**NOTICE OF A REGULAR MEETING  
BONDURANT PLANNING AND ZONING COMMISSION  
NOVEMBER 14, 2019**

**ITEM TITLE:** Resolution regarding the Revised Site Plan for Roadside Machinery & Supplies Co.

**From:** Maggie Murray, AICP  
**To:** City Council  
**Request:** Site Plan Approval – Road Machinery & Supplies Co (RMS)  
**Action:** For P&Z recommendation on November 14<sup>th</sup>, 2019

**From:** Maggie Murray, AICP  
**To:** Planning & Zoning Commission  
**Request:** Site Plan Review – Iowa Floor Covering  
**Action:** For P&Z recommendation on November 14<sup>th</sup>, 2019

Sheet 1 of 6

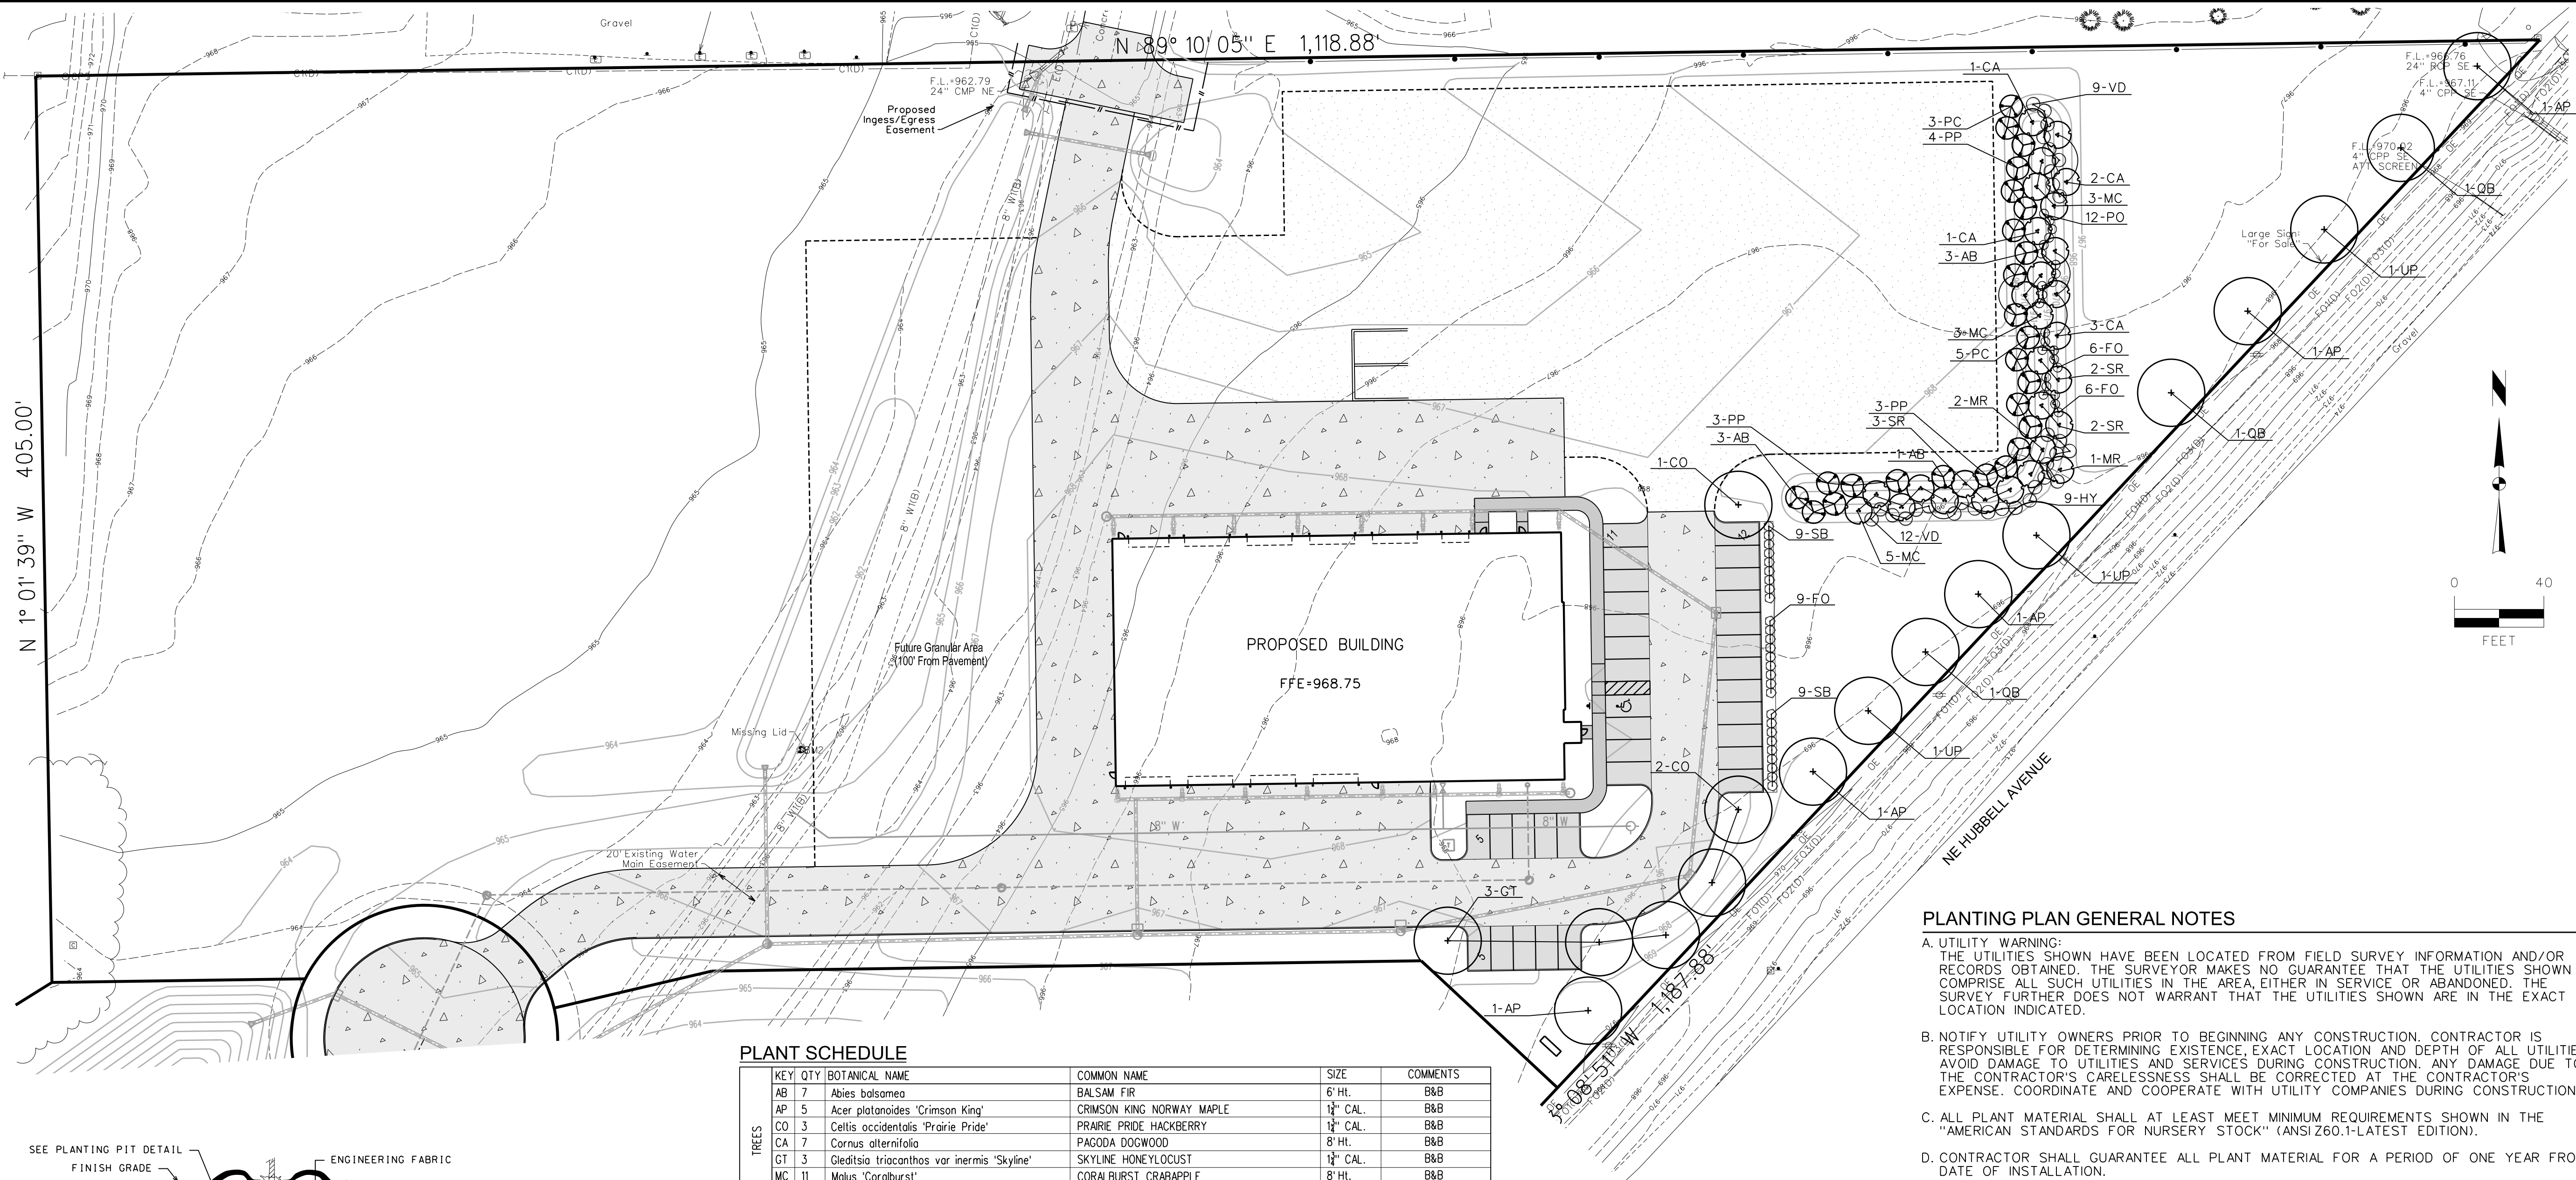
1. The hammerhead as proposed appears acceptable, but will need to be reviewed in more detail once detailed construction drawings for this hammerhead have been created.

2. Ownership of the hammerhead will need to be addressed. The site plan currently labels this hammerhead as being an ingress/egress easement. The eventual subdivision plat will either need to call this out as being a public street easement or designate this area as being public right-of-way. It is the City's preferred method that this area be designated as public right-of-way.

3. The proposed 31'-wide street width of the cul-de-sac meets the City's street width standards. The cul-de-sac meets SUDAS' minimum radius requirements.

4. The stormwater plan will need to be updated to reflect Bob Veenstra's comments, including but not limited to the following comments:
  - a. A total of 13.79 acres of the onsite area is tributary to the basin. The summary in the engineer's stormwater report indicating that 13.72 acres is tributary does not appear to be correct.

- b. The revised drainage plan indicates the area to the west of the SW boundary of the site will continue to drain overland to the southeast and will drain southerly between the west property line and the detention basin directly toward the right-of-way of Franklin Street SW. The natural ground slope in this area is to the SW, meaning overland flow should generally flow southerly. The extent of the swale that was shown in the previous site plan has been reduced. The key in this area is to ensure the runoff from the

property to the west is intercepted and turned southerly along the west side of the detention basin and not allowed to pond onto the property to the west.

- c. The revised site plan shows a 1.59-acre area located to the west and slightly to the northwest of the northwest corner of the RMS site. This area is allowed to drain overland to the east. The natural ground slope in this area is to the east southeast. Under the current site plan this offsite area, shown in blue on the attached drawing, drains overland toward the detention basin. This is a change from the previous site plan that intercepted the overland flow area in a ditch and conveyed it southerly around the west side of the detention basin. Based on the natural slope of the land the offsite area in blue in the drawing should drain to the detention basin.

- d. The westerly approximately 2.84 acres plus the offsite area drains overland to the detention basin. The southern part of this area should be shaped so that the overland flow is conveyed to the detention basin and not to the cul-de-sac.

- e. The overflow elevation for the detention basin is 963.25. The freeboard provided is 0.90 feet. The City normally requires a freeboard in the range of 1.0 feet. Historically, the City has approved detention basins with a freeboard of 0.90 feet as being reasonably close to its target of 1.00 feet unless there is a downstream risk that requires a greater freeboard. Engineer to confirm the downtown risk was reviewed.

Planning staff would like clarification from the Commission on the outdoor gravel parking area that was allowed on the original site plan that was approved in September 2019. A gravel area has also been shown on the amended site plan to the north and east of the building. The amended site plan also shows a potential future gravel area to the west of the paved driveway area. If this gravel was specifically allowed as part of the September 2019 site plan approval, then it should also be considered as part of this current amended site plan approval. As a reminder, below is a summary of the Zoning Code relative to paving and outdoor use requirements of the M-1 District:

1. The Zoning Code requires that whenever parking/drive areas are visible from the right-of-way or residential areas, at least 5% of the parking/drive area shall be greenspace. Please confirm that at least 5% of the parking area is interior greenspace. Perimeter greenspace is not counted toward this required 5%. Site plan applicant to confirm that this requirement will be met.
2. Section 179.02.3 of the Zoning Code has a table of screening requirements where certain uses are proposed adjacent to other zoning districts. The M-2 District is adjacent to the immediate

RMS development proposed. When an M-1 District is adjacent to an M-2 District, a Type B screen between the two uses is required. Site plan applicant to update the landscaping plan accordingly.

3. Section 179.01.2.I.1.a of the Zoning Code requires adequate treatment or screening of loading docks, loading areas, non-residential overhead doors, garbage dumpsters, and HVAC units from public right-of-way and adjacent properties. Site plan applicant to detail how this will be met, or update the landscaping plan accordingly.
4. Section 179.01.2.I.1.b of the Zoning Code requires that roof mounted mechanical units be screened from view of public right-of-way. Site plan applicant to confirm that this requirement will be met.
5. The original elevations submitted did not label building materials proposed. Site plan applicant to confirm that the materials proposed meet

1. That this approval is for the amended site plan only and not approval of the subdivision plat. The subdivision plat will need to be reviewed at a later date.
2. That ownership of the proposed hammerhead be addressed prior to construction to the hammerhead. Ownership meaning either a permanent street easement or public right-of-way dedication.
3. That an updated stormwater report be submitted to the City for review to ensure the City Engineer's comments have been addressed. If the City Engineer's comments have been addressed, this stormwater report will be considered approved.
4. That the site plan applicant address the minor site plan comments #1-5 as listed in this staff report. If the applicant can detail that all of these items can be met, staff will administratively approve this updated information.

**Submitted Site Plan:**

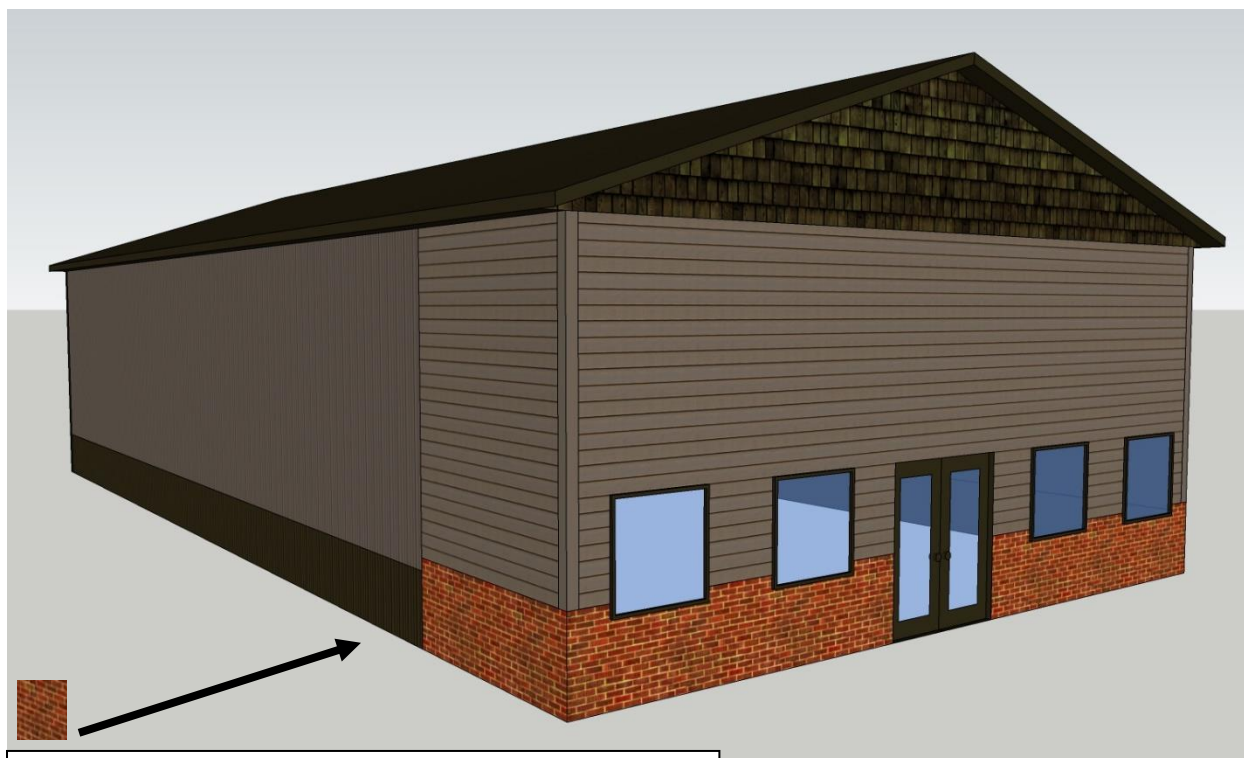
This type of retail use would typically require at least 7 parking spaces to be provided on site. However, per Section 178.10.6 of the Zoning Code, parking requirements in the C-4 District can be reduced on a

case-by-case basis. When considering a reduction in parking spaces, the P&Z and Council will need to review the anticipated peak parking and the developer's alternative strategy for accommodating parking elsewhere near the location. The developer is requesting a reduction of 7 parking spaces. The developer's justification for such request: they do not anticipate hiring any new employees as a result of this project, their business is open during daytime hours which is opposite of some of the other bar/restaurant businesses of the area, and their current employees and customers have no issues finding street parking.

1. That as allowed administratively per Section 179.01.3 of the Zoning Code, that the engineer-prepared site plan requirement be waived for this site plan;

**Submitted Building Elevations – Rear and North Side:**

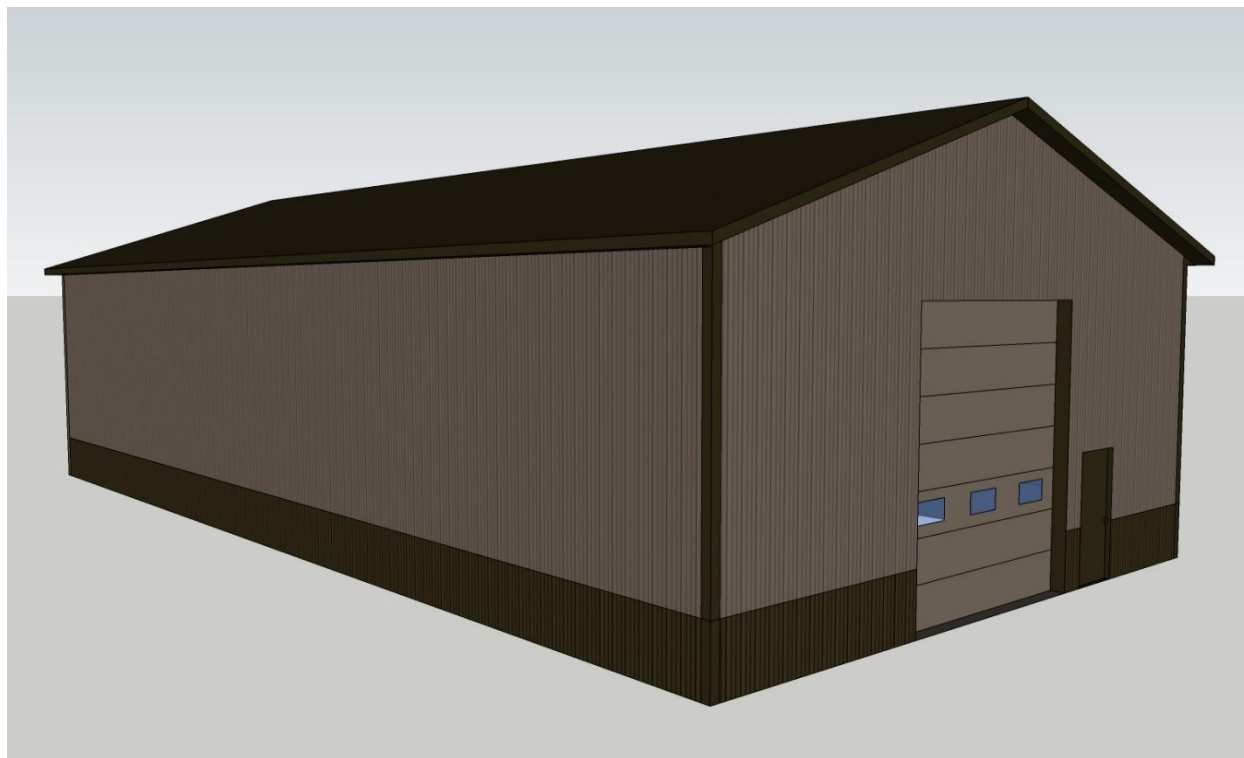
The building's north and west facades are not visible from the street right-of-way; as such, no building design/material requirements apply to these areas. These areas will be comprised of a vertical two-tone metal.

11/14/19 Update – the developer will extend brick in the knee wall area for the entire extent of the south knee wall area instead of just the first 10' as originally proposed.
